April 30, 2008

Re: Draft North Coast Instream Flow Policy

**A Critical Review of the December 2007 State Water
Resources Control Board Draft Policy for Maintaining
Instream Flows in Northern California Coastal Streams and
Supporting Documents**

FIGURE 9-2
"Water Cost" available diversion in smaller drainage areas in Santa Rosa Creek watershed

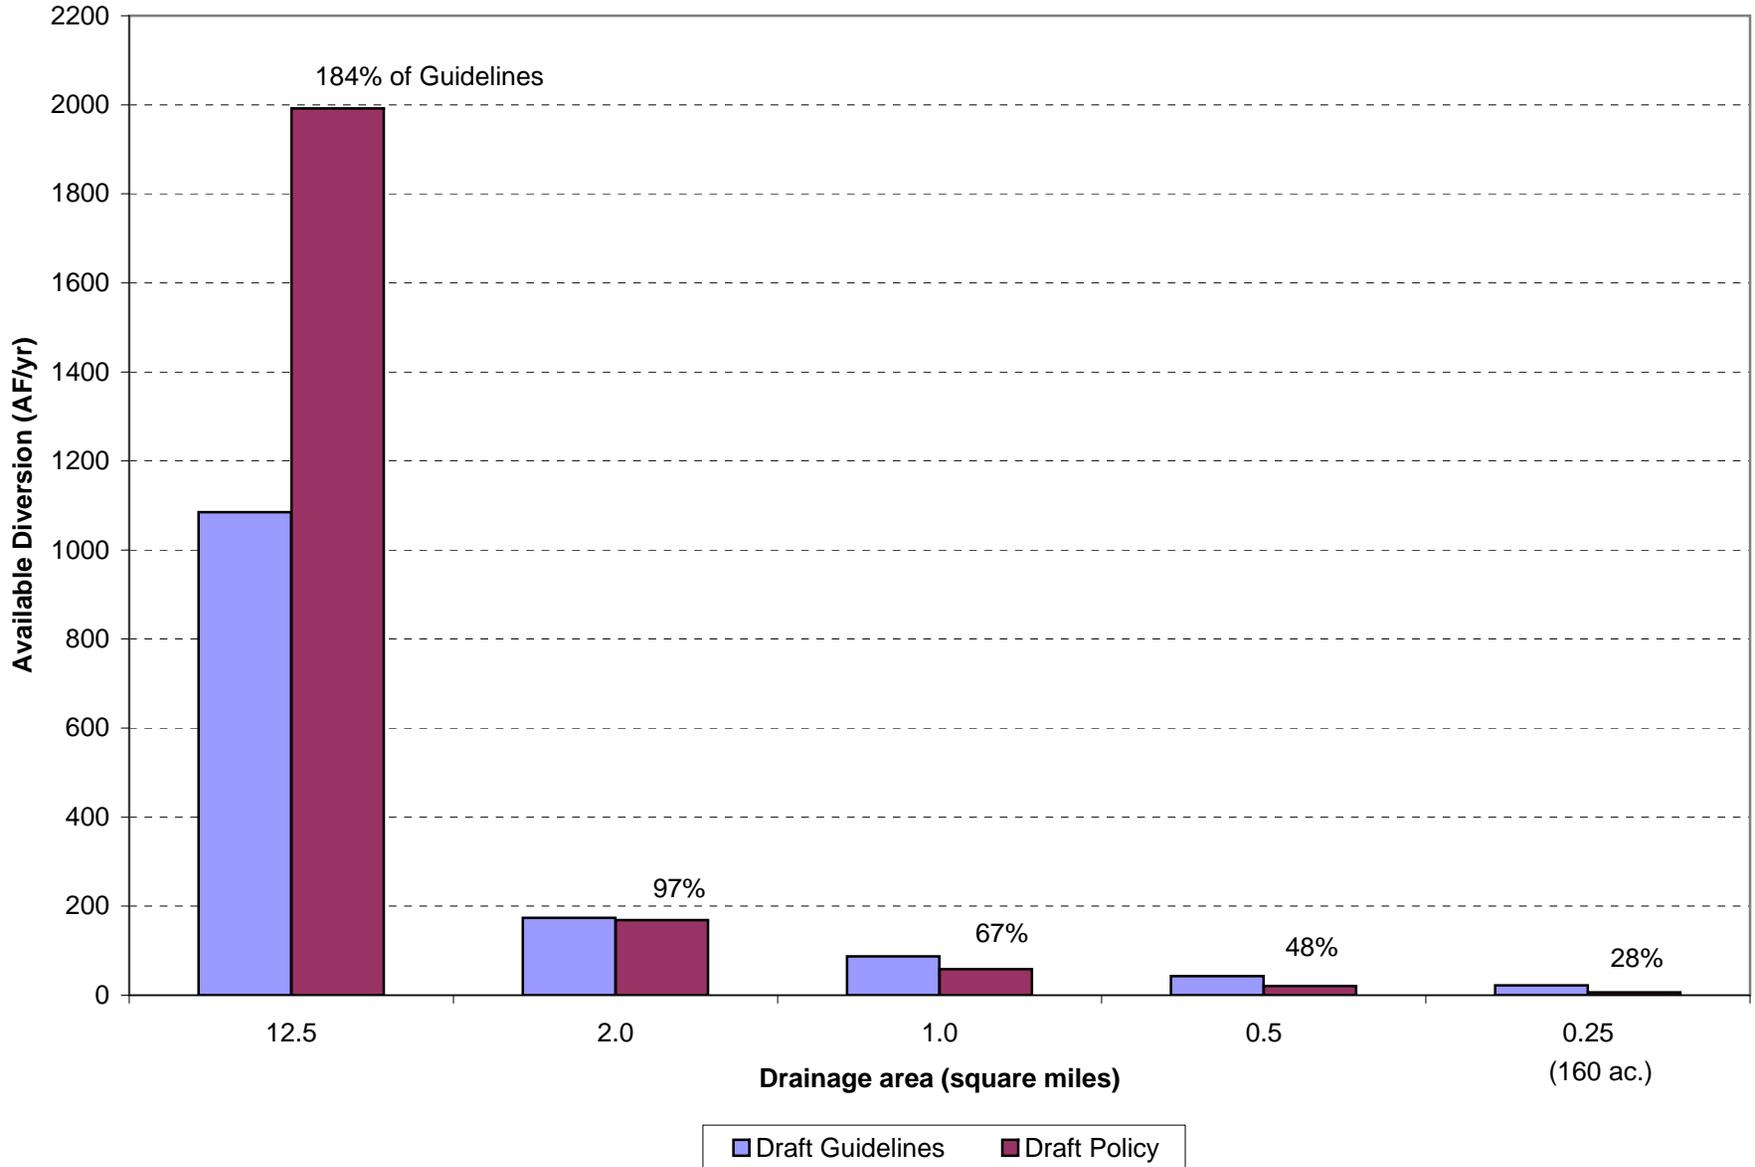
Figure 9-2 (attached) extends the analysis to drainage areas more representative of pending applications. Because of the way the minimum bypass flow was formulated, the Draft Policy is particularly restrictive in small drainage areas. Most pending applications for storage are not down near the base of the watershed where the validation sites were located, but rather are located higher in the watershed with much smaller drainage areas. Using Santa Rosa Creek, one of the validation sites as an example, an analysis was conducted to compare relative restrictiveness of the Draft Guidelines and the Draft Policy on small watersheds. Applying the same algorithm as used in the water cost analysis, but with smaller drainage areas, water availability within the regional criteria of the Draft Guidelines and Draft Policy were calculated and are summarized in Figure 9-2. As can be seen, as the drainage area decreases the Draft Policy becomes dramatically more restrictive of diversions as compared to the Draft Guidelines. A similar analysis and result was found for Salmon Creek, another of the validation sites.
